Technical Service Bulletin

Cobra Motorcycle Mfg.

TSB0414 CX65 CDI unit

December 20, 2013

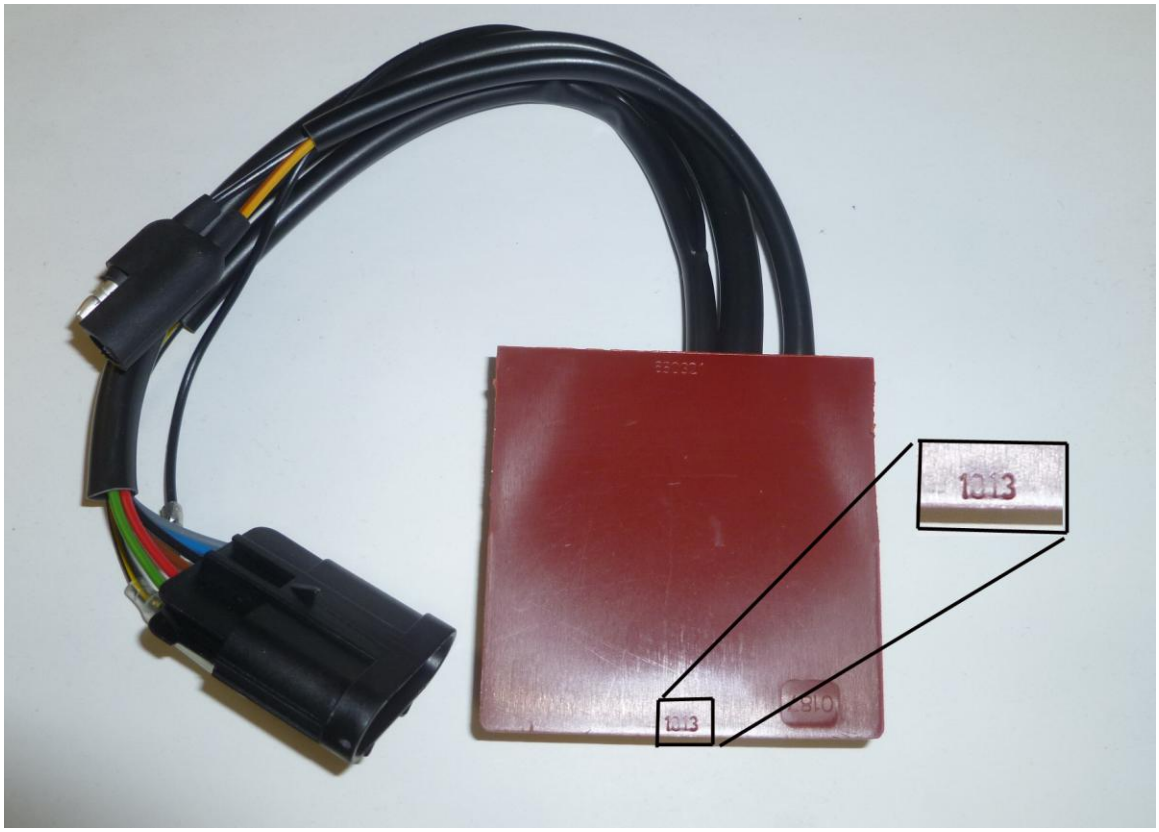
The 2014 CDI unit for the Power Valve CX65 has improved ignition values that reduce or eliminate the high RPM 'popping' some have experienced in 2013. From this time forward the new 2014 box will be considered the standard service replacement for all CX65 power valve bikes from 2012 on.

The 2014 CDI box can be identified by the date code. It will have a date code of "1013" (October 2013) or later as identified in the picture below.
